Report to Planning and Environment Committee

Subject: DBNM Investment & Management Ltd. (c/o Siv-ik Planning & Design)
383 Clarke Road & 1906 Whitney Street
File Number: Z-9779, Ward 2
Public Participation Meeting

Date: November 12, 2024

Figure 4 - Conceptual Site Plan (Received August 2024)

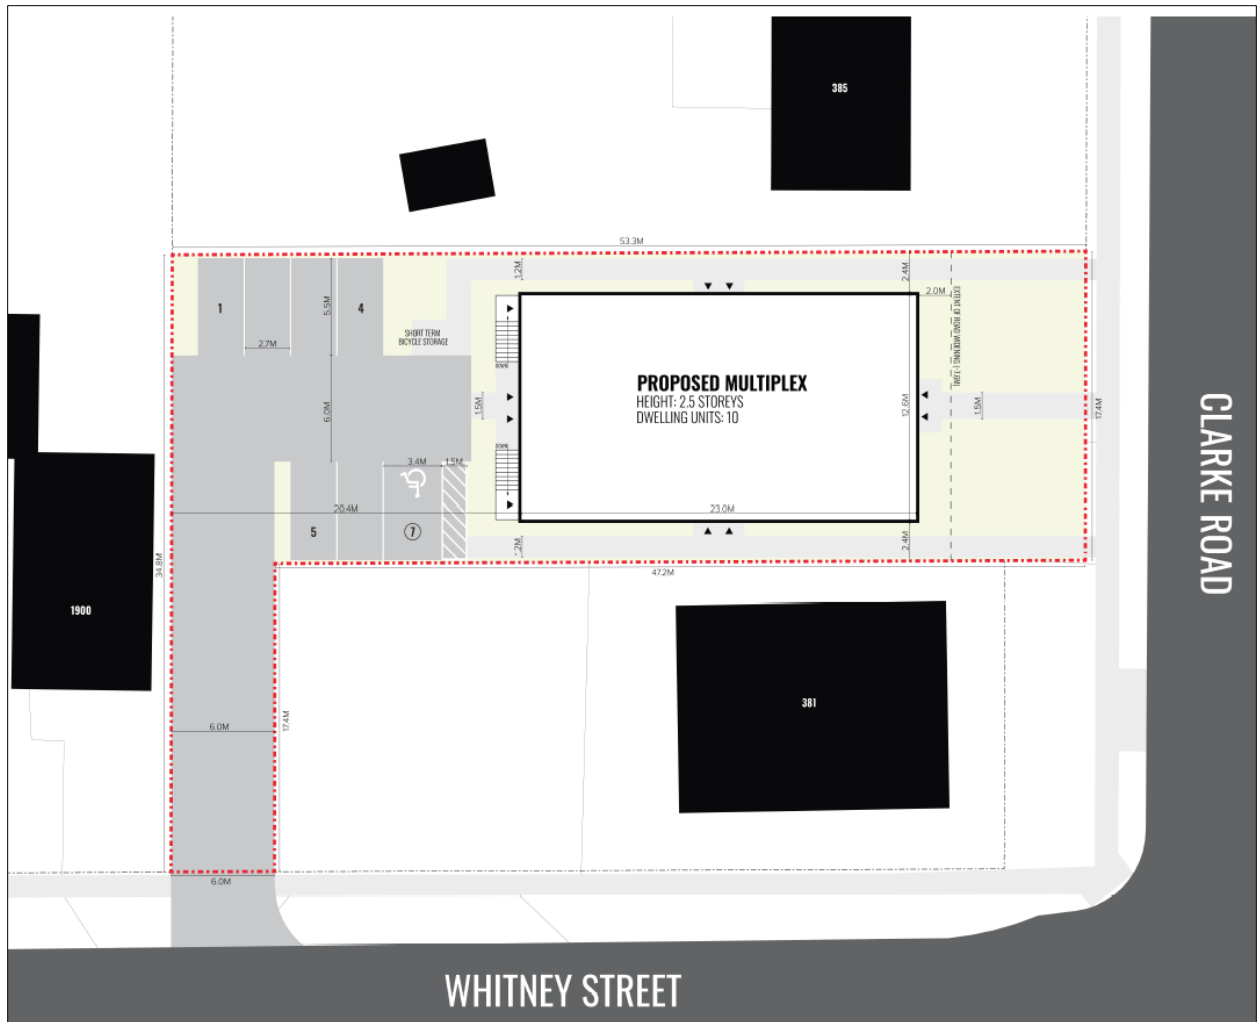
- Incorporate enhanced all-season landscaping to buffer and screen below-grade units from Clarke Road and the rear parking area. Ensure the landscaping effectively shields the below-grade units/floors from headlight glare coming from the rear parking lot and the existing commercial development on the east side of Clarke Road.

- Confirm a road dedication of 7.942m is shown on the concept plan. Ensure draft reference plan has been submitted to Geomatics (Geomatics@london.ca) for review
